## **ADDENDUM #2**

PROJECT: City of Waycross - Wastewater Treatment Plant Generator Replacement

ACTION: Plan/Specification Changes

DATE: September 4, 2020

**CONTENT:**  
 ONE LINE DIAGRAM

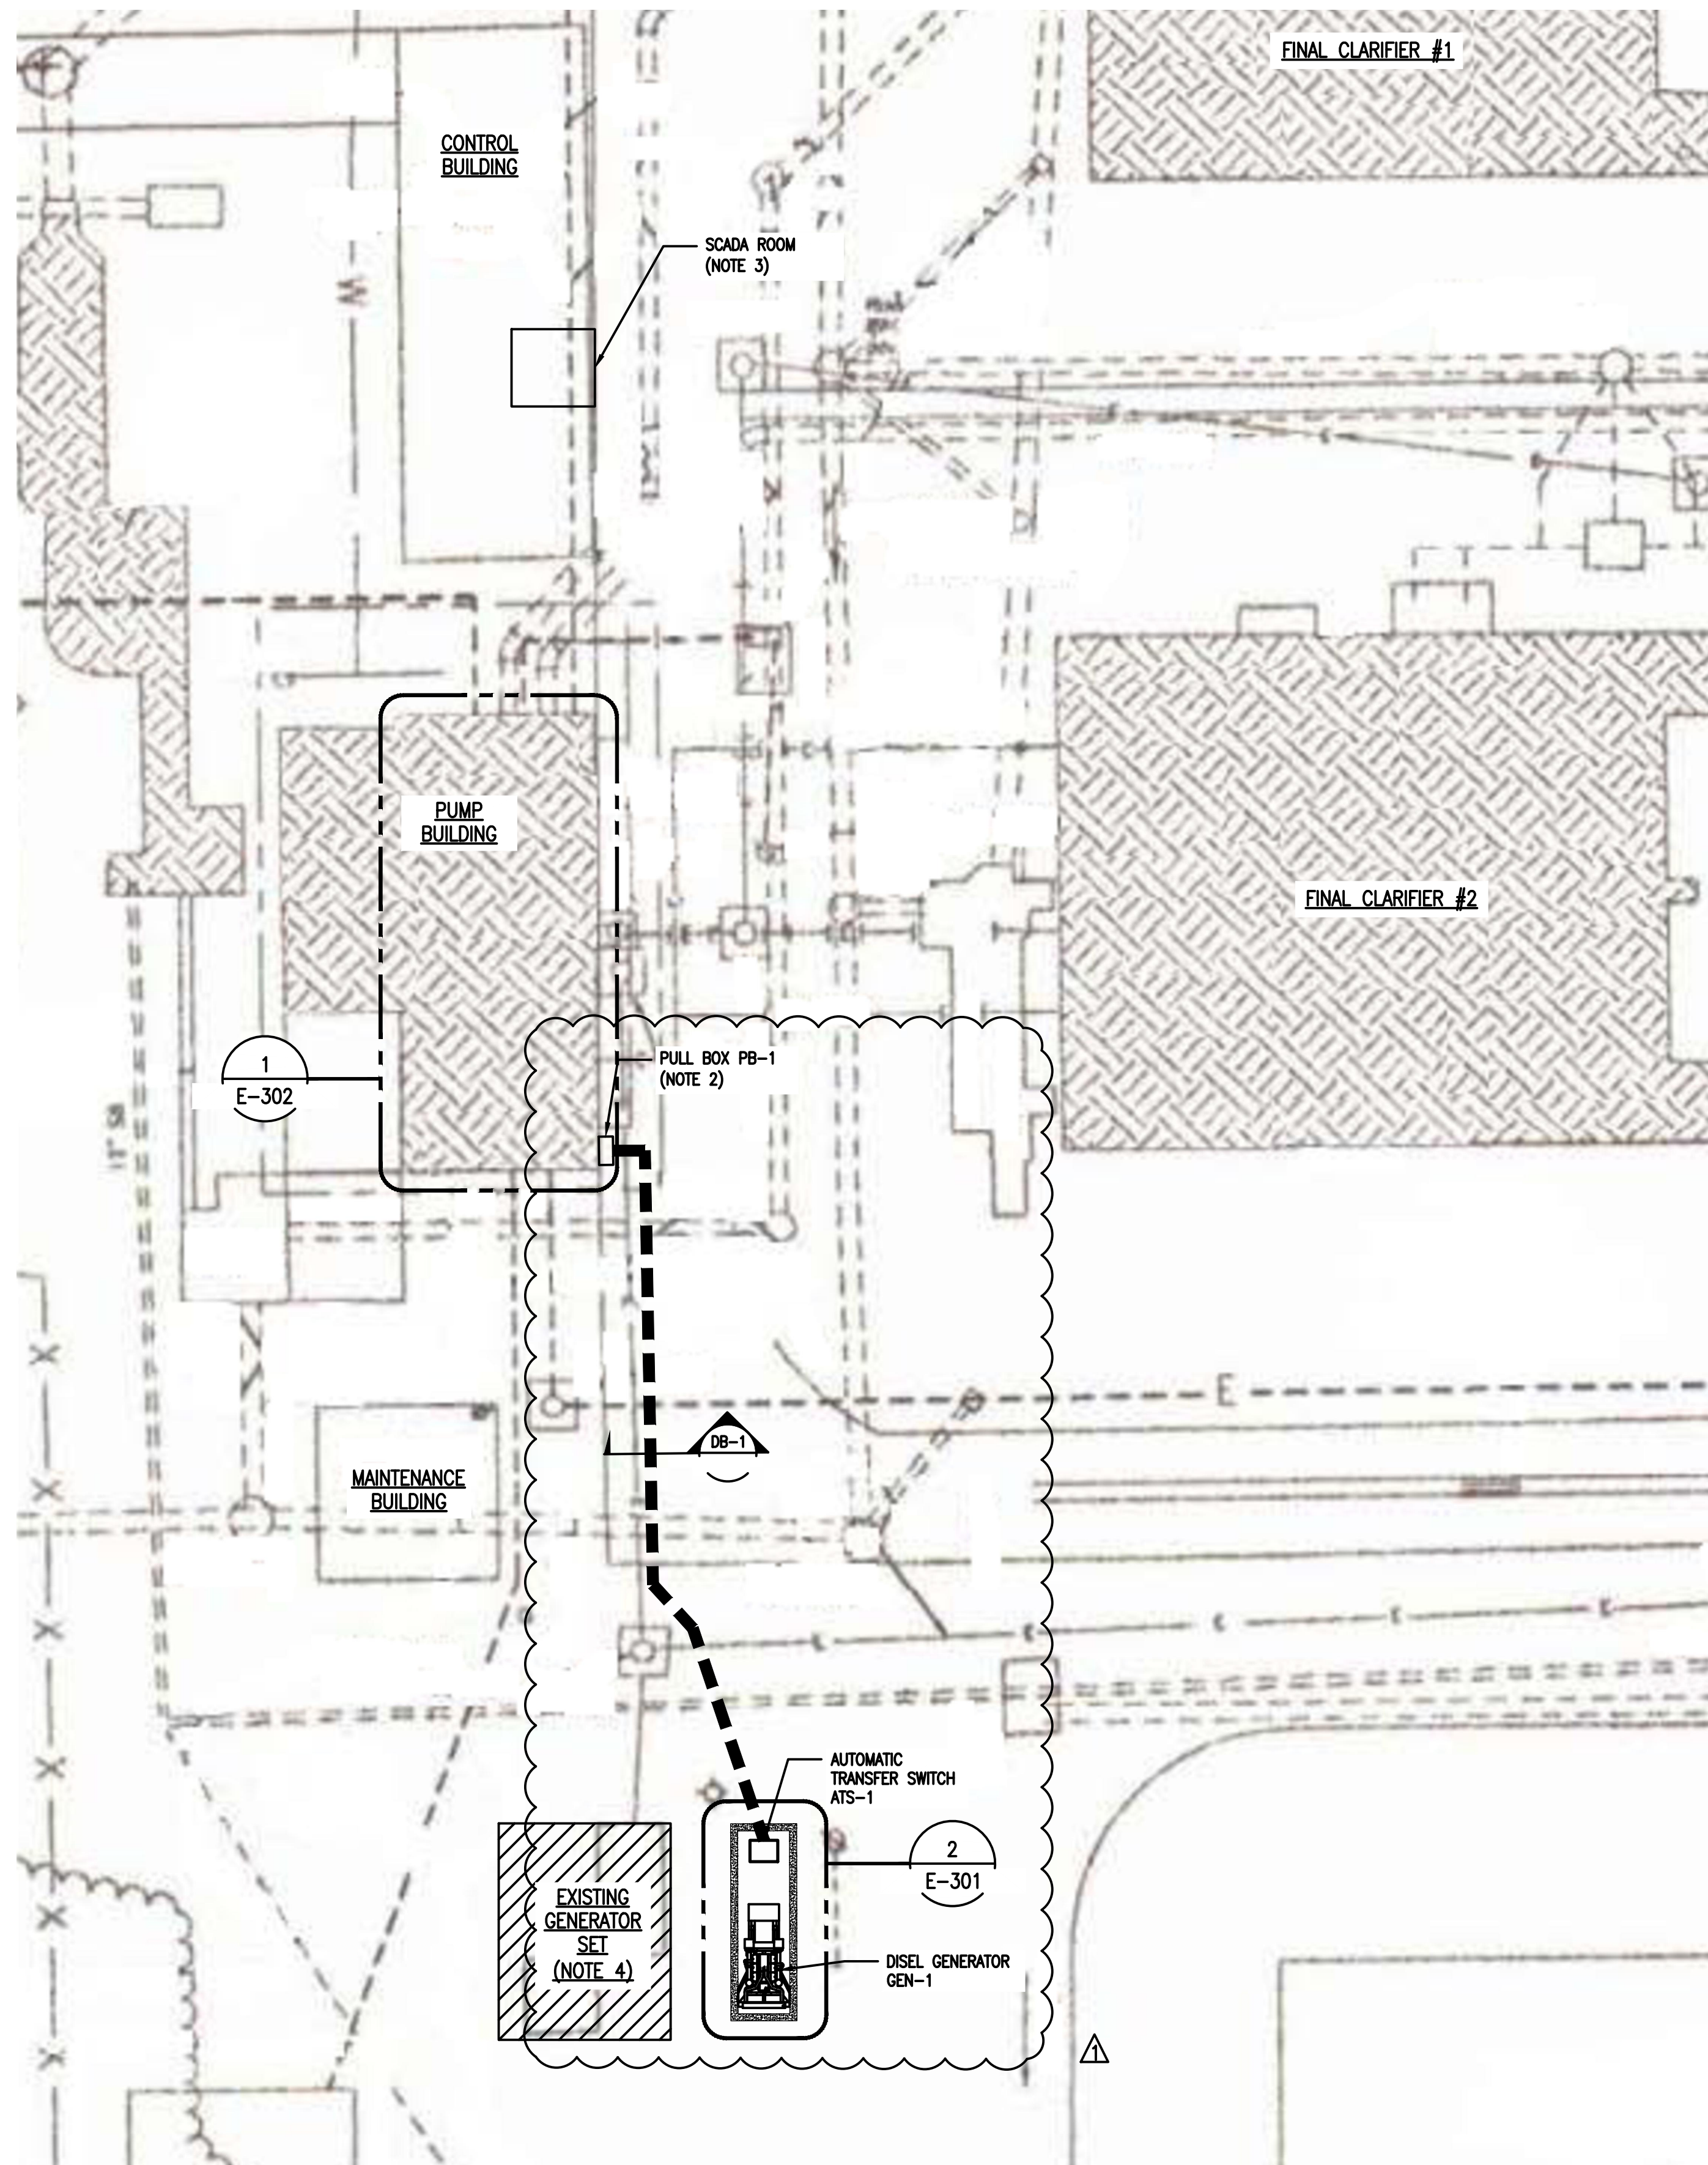
4. **Question:** Stagger Starting – 1250kW vs. 1500kW.

a. Loads are all listed under step 1, its possible to achieve this. However, we see that many of the large motors have VFD’s. It maybe beneficial **to introduce a time delay** for the 150 hp motors and the 75 hp motors (motors or VFD’s). Its likely we, and others, will have to quote 1500kW gensets rather than 1250kW gensets. Introducing a time delay between some of these motors will **avoid upsizing to 1500kW**. We also have a 1350kW available, but 1250kW is enough since cumulative loads add to 1040kW. (82% of 1250kW)

b. It possible to add this time delay for some of the motors that have VFD?

5. **Question:** Can we offer Factory enclosure as a VE package, and would adding a floor qualify our factory enclosure as walk-in? We can certainly offer walk-in from a vendor as well.

**PLAN SHEET CHANGES:** Plan Sheet numbers E-001, E-101, E-301, E-302, and E-901 have been revised to reflect the new location of the generator. The revised plan sheets are included with this addendum and should be used in the preparation of bids.

**Answer:** In case 1250kW generator can’t start the loads in one step as specified on the drawings, contractor shall include time relays to provide the required load staggering as recommended by the generator manufacturer.

**Answer:** This issue is addressed in the Bid Form as part of this addendum- Item 2 above. Factory enclosures for the Generator are acceptable. The Generator vendor shall ensure that the generator enclosure will house a disconnect switch, stepdown transformer and distribution panelboard with all generator accessories prewired as indicated on the one line diagram drawing E-101. All the required platforms/stairs shall be included with the proposed generator to meet applicable codes. Factory enclosure shall provide the required clearances for proper generator service and maintenance. For the Generator vendors, who

are not able to house Disconnect switch and Stepdown transformer inside the generator factory enclosure, the contractor shall install outdoor rated Disconnect switch and 480-208/120, 3Ph Transformer next to the generator. Disconnect and Transformer shall be properly selected for the Voltage and amperage ratings and shall be provided with NEMA 4X SS enclosure to withstand corrosive environment. The contractors may submit two options for the City's consideration – base bid with walk-in enclosure (as specified on the drawings and specifications) and alternative bid with Factory enclosure (including all the costs for external disconnect switch and TFR installation and wiring) as described above.

CONTENT:  
 OVERALL ELECTRICAL  
 SITE PLAN

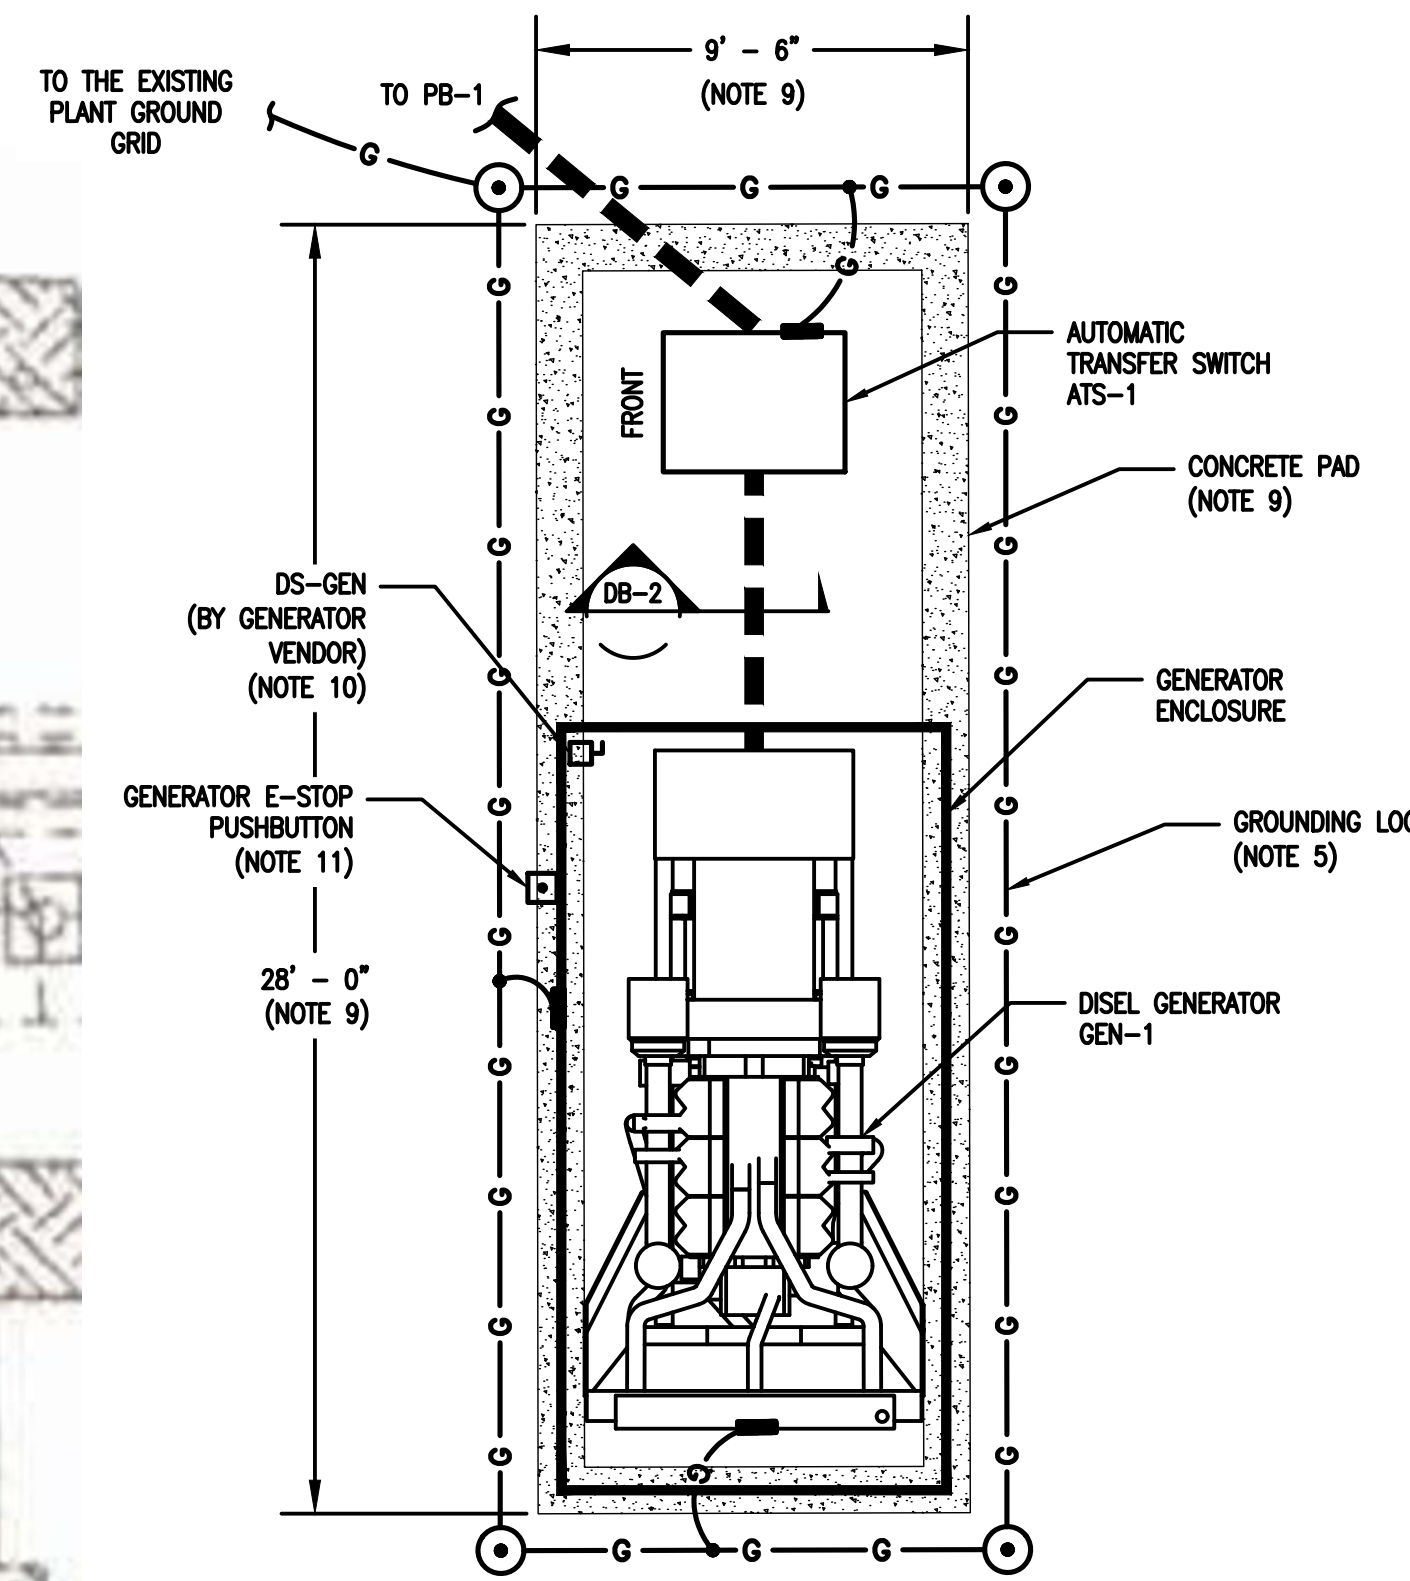
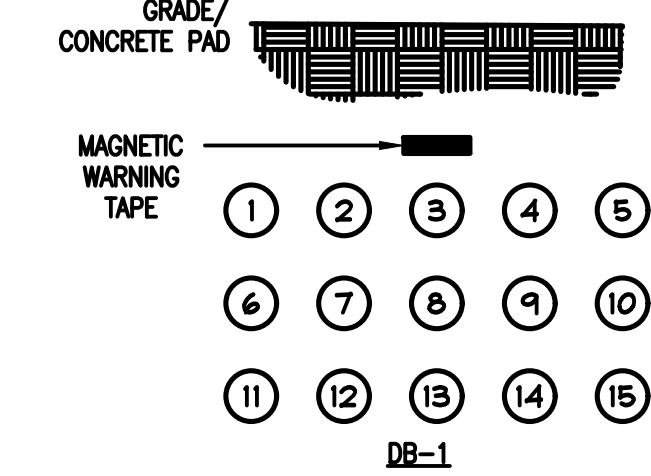
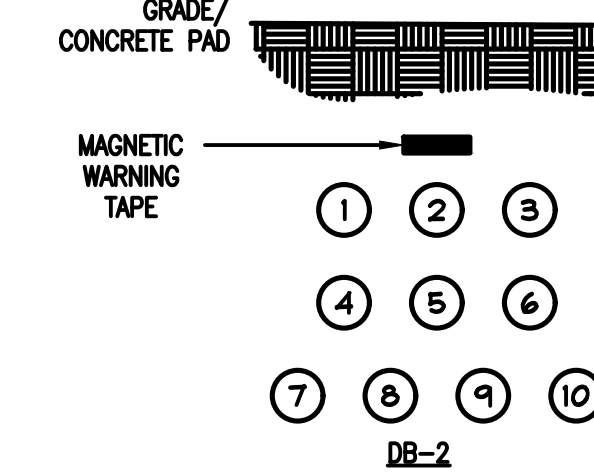
3. **Question:** While on site several 18 wheel trucks entered the plane to dump their loads. Can road be closed while new electrical duct bank is being installed?

**Answer:** Location of generator has been changed. Refer to revised plan sheets E-001 – E - 901 included with this addendum for revised location.

CONTENT:  
 PUMP BUILDING  
 ELECTRICAL PLAN

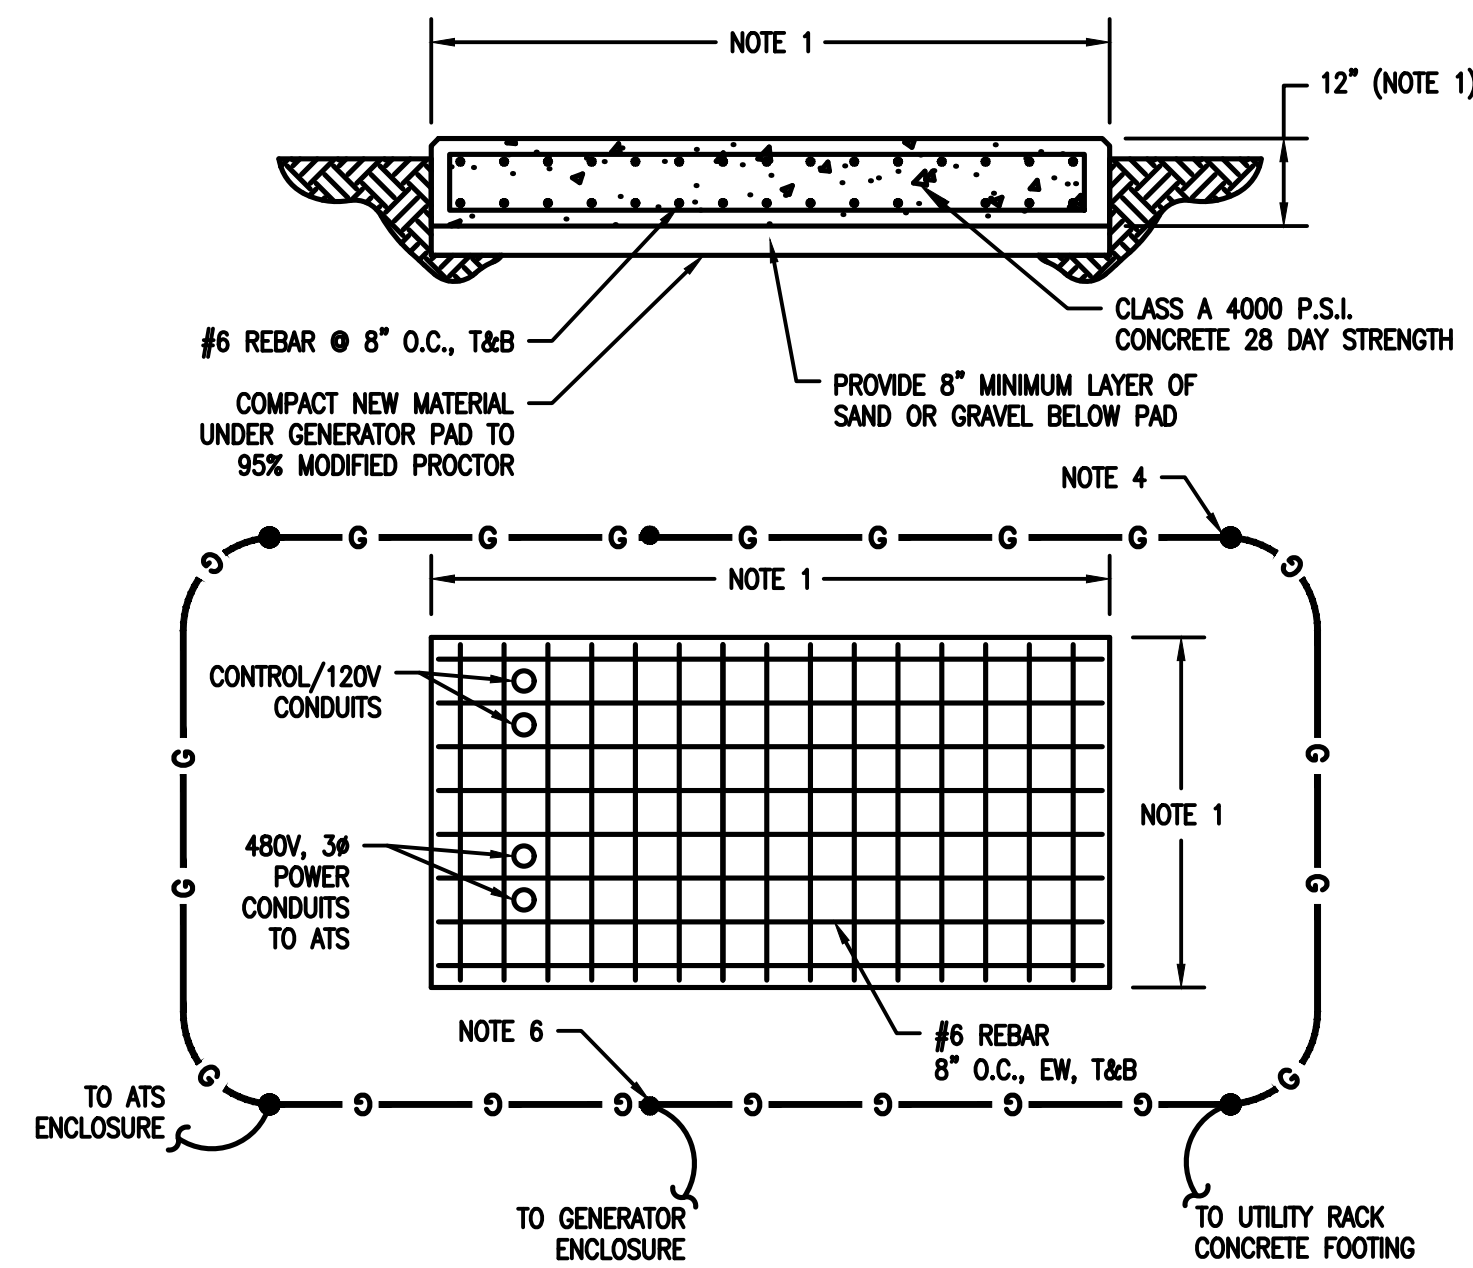
1. **Question:** Switchboard #2 is a stand-alone SWD. Currently the existing service is entering from the top but whomever installed a normal power feeder to the ATS also ran the raceway across the top of the SWD. How long of a power outage will be allowed to demo existing and install new service. The current service is 1200amp (3) sets of four inch and we are replacing them with (6) sets. There physically is not enough space in the top of the gear for both sets.

2. **Question:** Entry point shown on contract drawings already has HVAC installed in the area and there is an electrical manhole in the same space. Moving west is not an option due to existing electrical already being surface mounted. Moving east will have us going through a shower area. Please advise.

**Answer:** The contractor shall install power conduits (SWBD-1 to new ATS and from new ATS to SBWD-2) to the closest proximity to the Switchboards to minimize shut down time during cables/conduits connection to the electrical equipment and demolition of the existing conduits.

The maximum shutdown time should not exceed 2 hours and only between the hours of 2:00 AM and 5:00 AM during weekday nights. Should the installing contractor need more downtime, he/she shall install temporary power to power the facility.

**Answer:** The contractor shall adjust the building entry points as needed to avoid interference with the existing utilities. Run the incoming conductors through “storage” or “Open Air Storage” area around Bathroom and penetrate the Electrical room from South side.
